# MONITORING YEAR 4 ANNUAL REPORT

## OWL'S DEN MITIGATION SITE

RE: Owl's Den Mitigation Site-Year 4 Monitoring Report  
Final Submittal for DMS  
Contract Number 004673, RFP Number 16-004110, DMS# 95360  
Yadkin River Basin – CU# 03040105; Union County, NC

Wildlands Engineering, Inc. (Wildlands) has reviewed the Division of Mitigation Services (DMS) comments and observations from the Owl's Den Mitigation Site Draft Year 4 Monitoring Report. Wildlands walked the site on 1/7/2019 to evaluate the site condition after the beaver dam was removed. Wildlands confirmed that the streams are stable and that monitoring features have not impacted by the beaver dam. The report text has been revised for the final draft to reflect the most current condition of the site. The following are Wildlands responses to your comments and observations from the report noted in italics lettering.

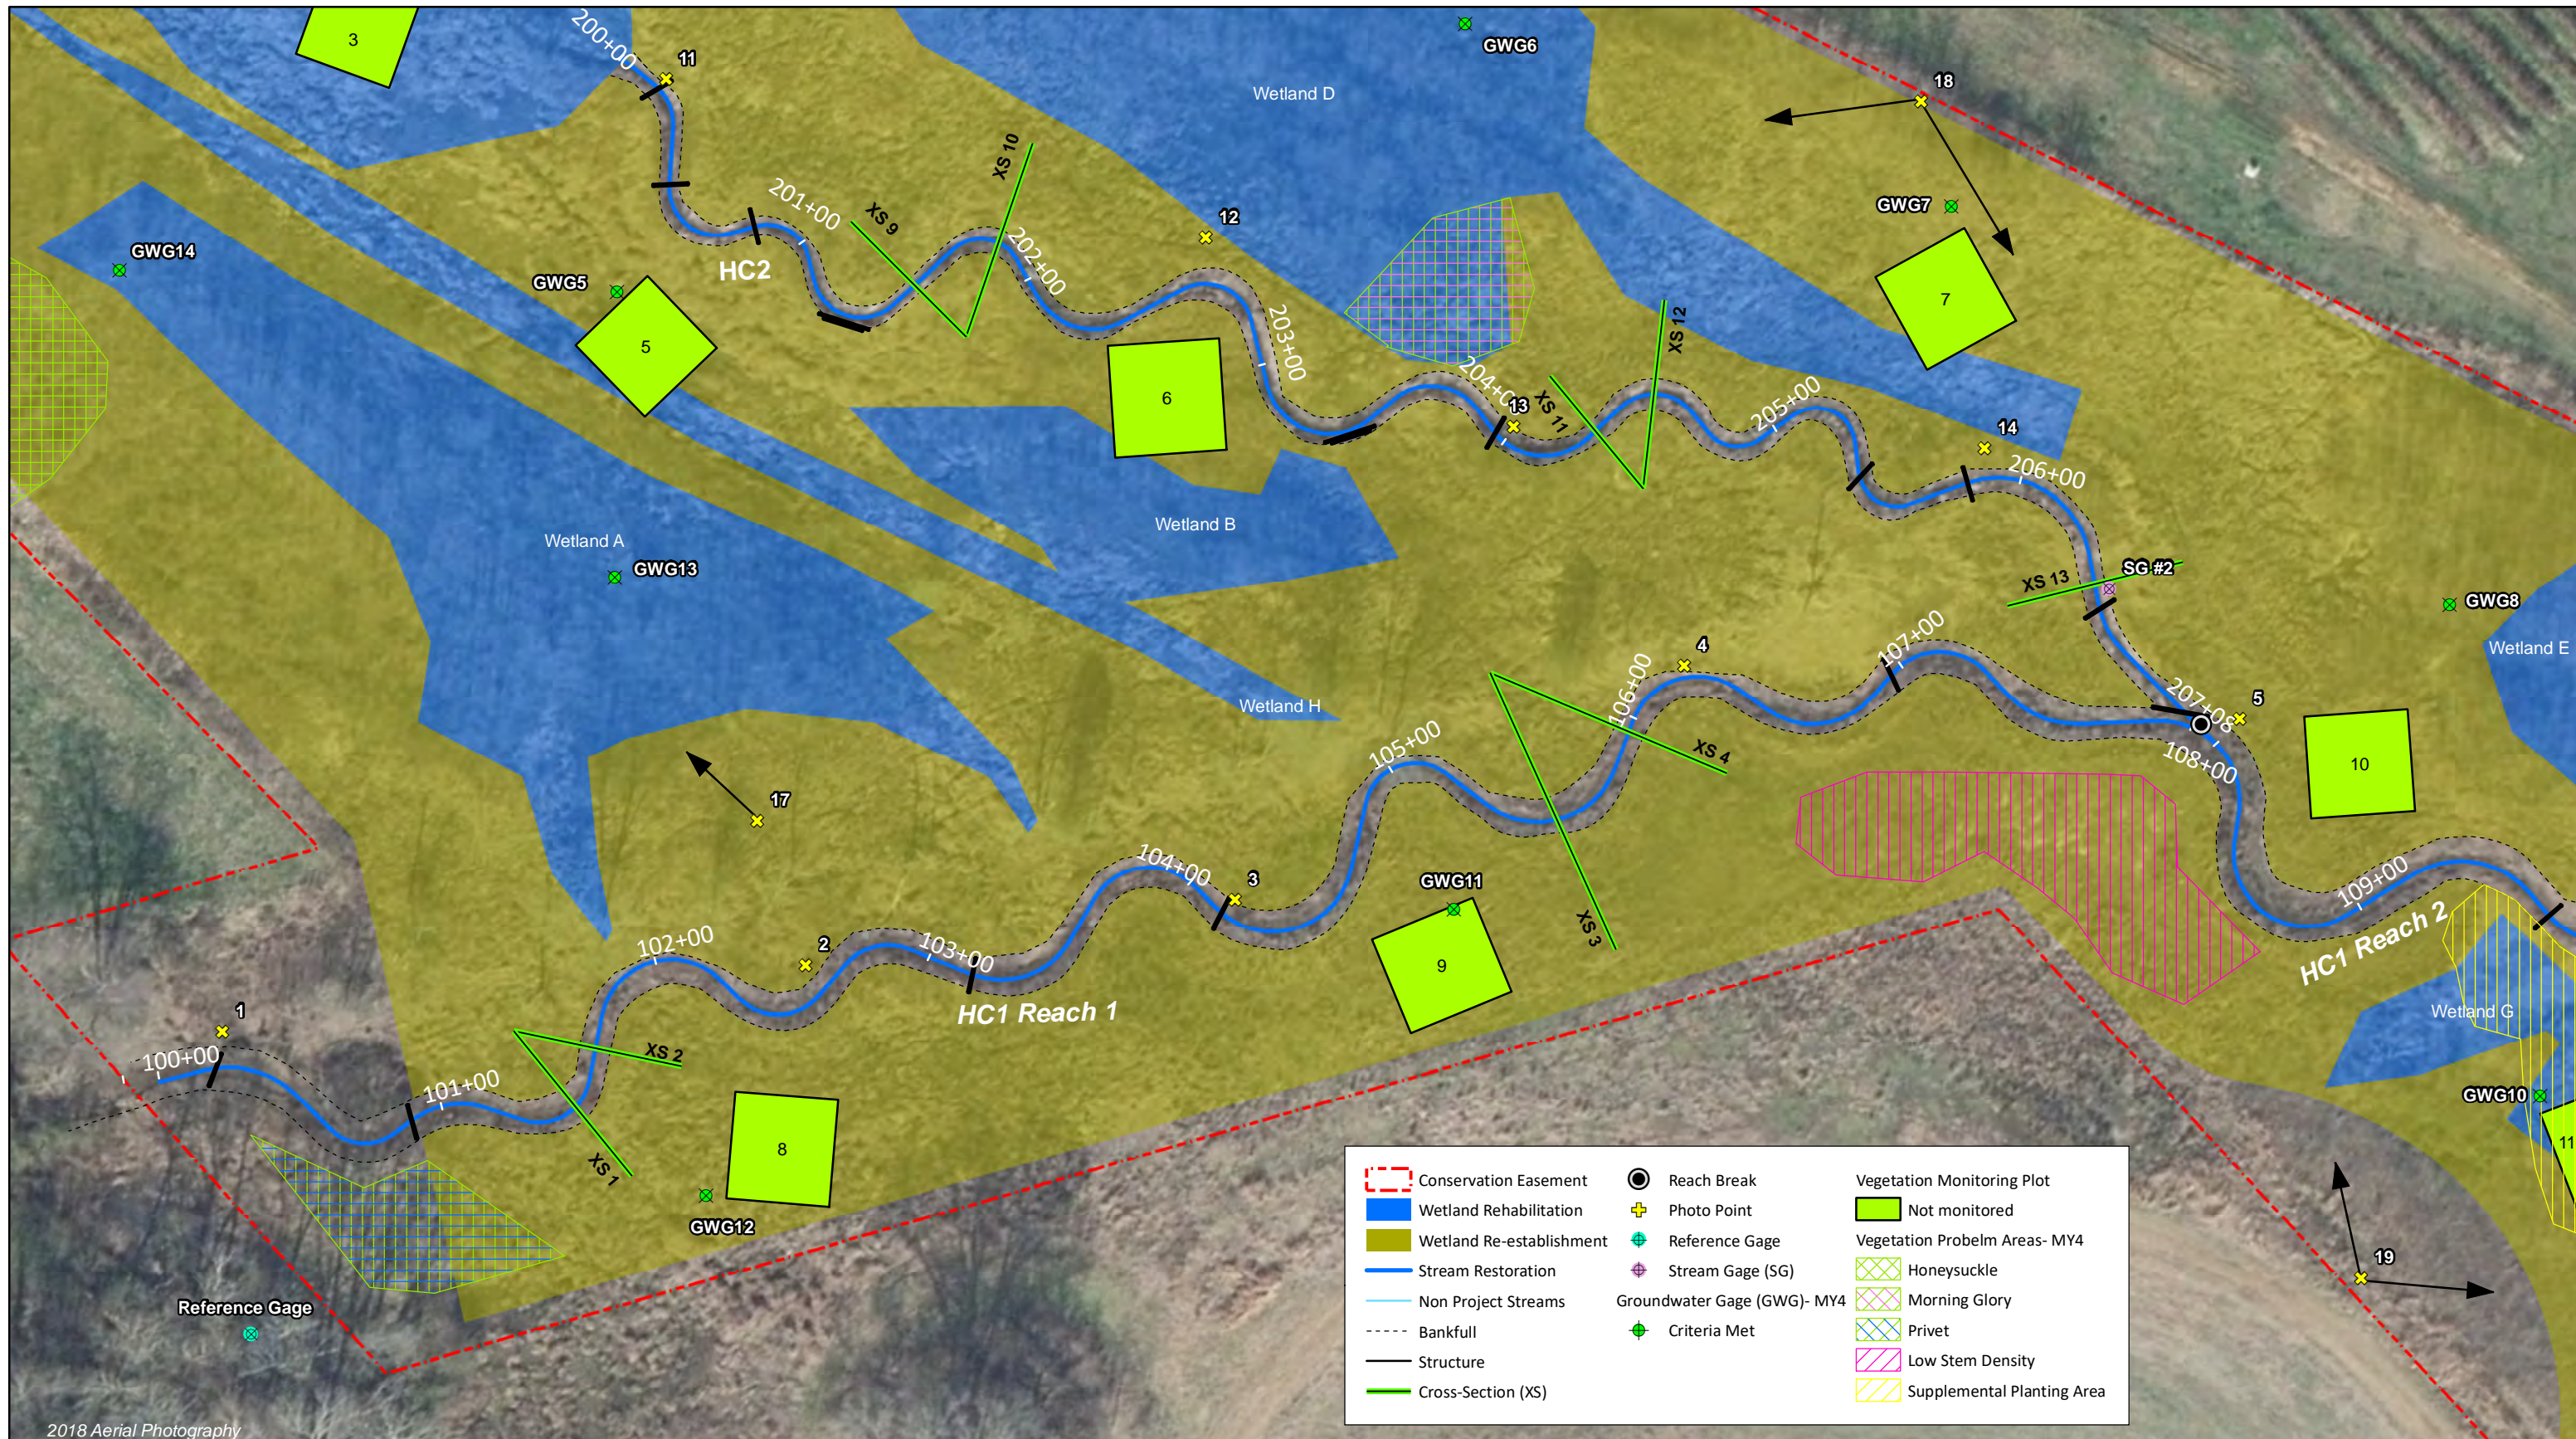
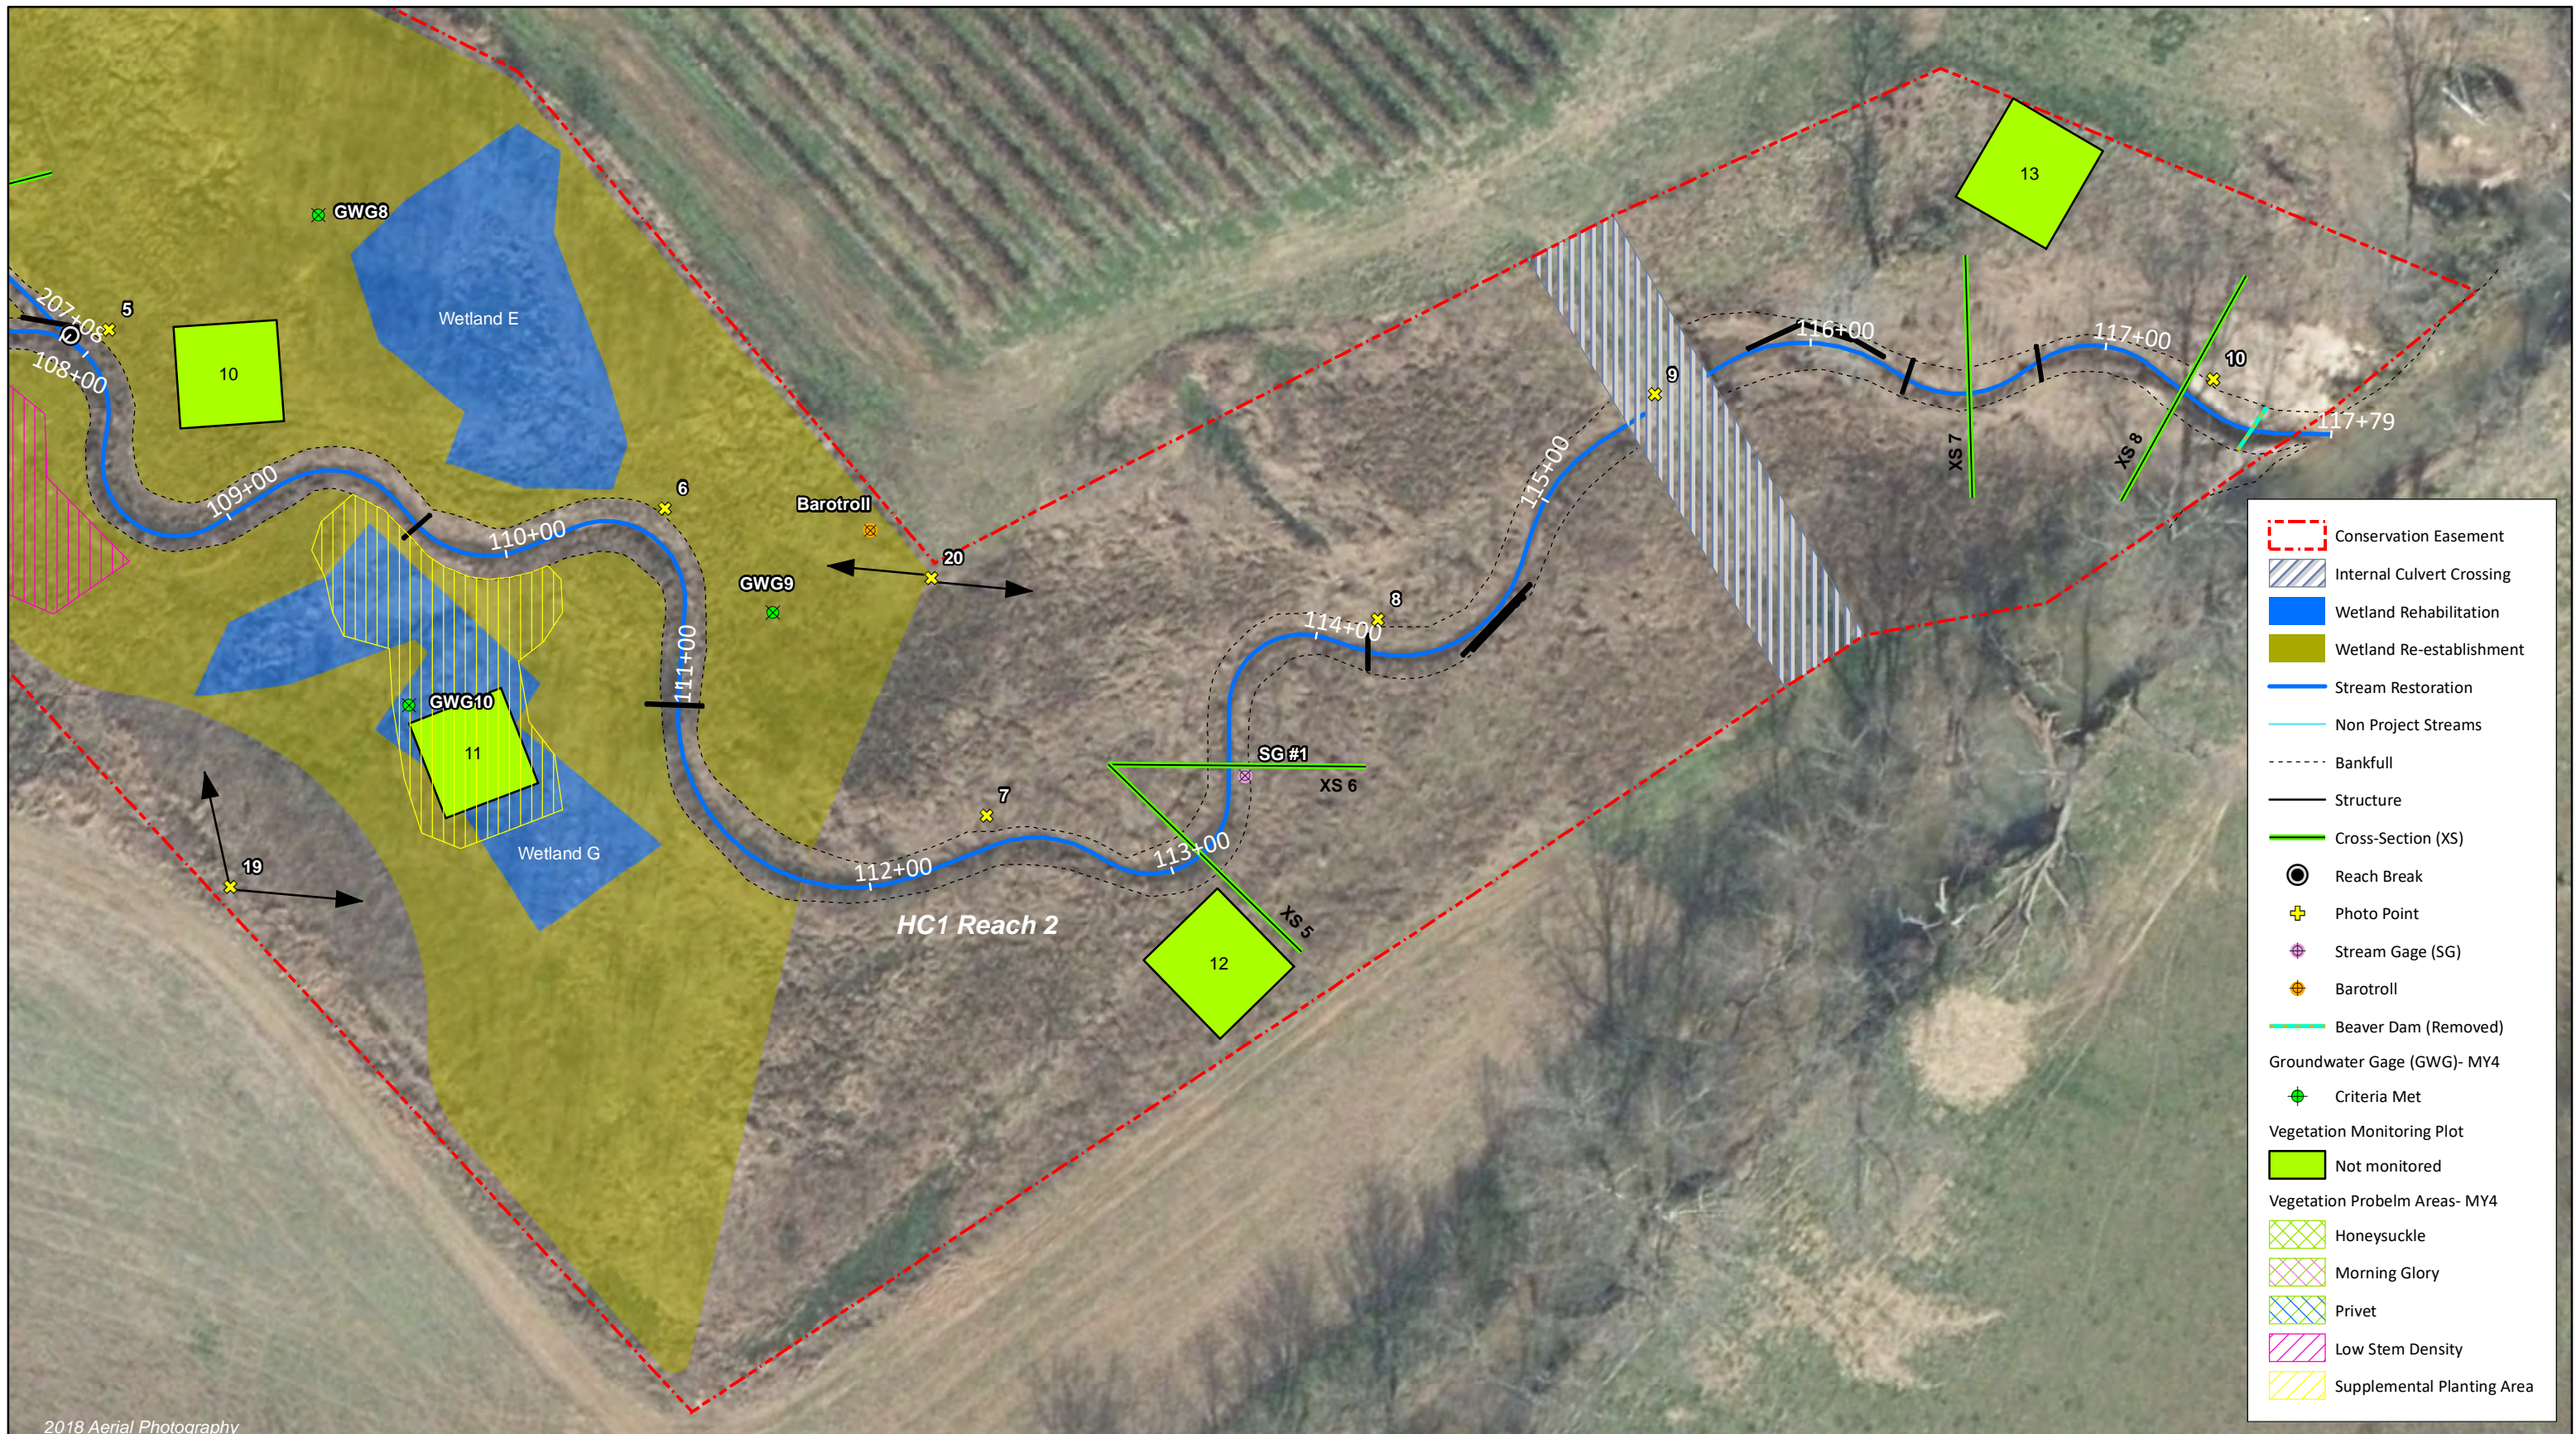
**DMS Comment; Section 1.2.3; Please show and identify the March 2019 replant area on the revised CCPV maps. In the report verbiage, please also identify the approximate number of plants installed. Please QA/QC this section for grammar errors/ run-on sentences.**

*Wildlands Response; The CCPV maps have been updated to include the supplemental planting area. The approximate number of plants installed have been added to the report text. The report text was reviewed for grammar errors/ run-on sentences.*
